IP Camera Firmware Version: V5.7.40 Release Note

Firmware		
Basic Information	Firmware Version:	IPCH_H8_EN_STD_5.7.40_220804

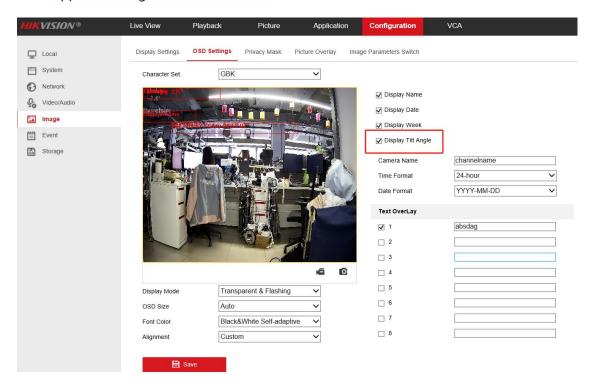
Support Vibration Detection function

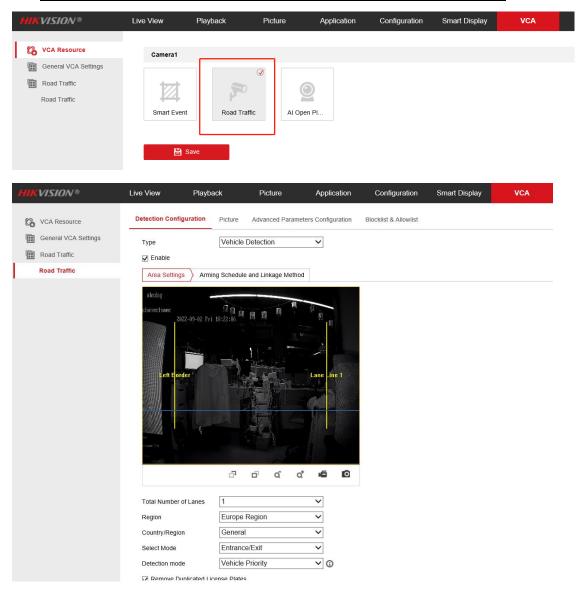
Support Tilt Angle detection function

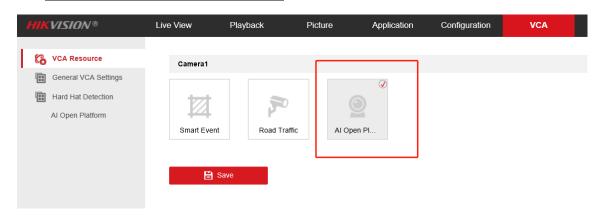
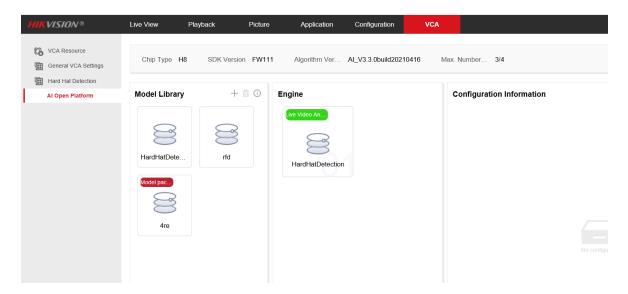
Support Hard Hat Detection function
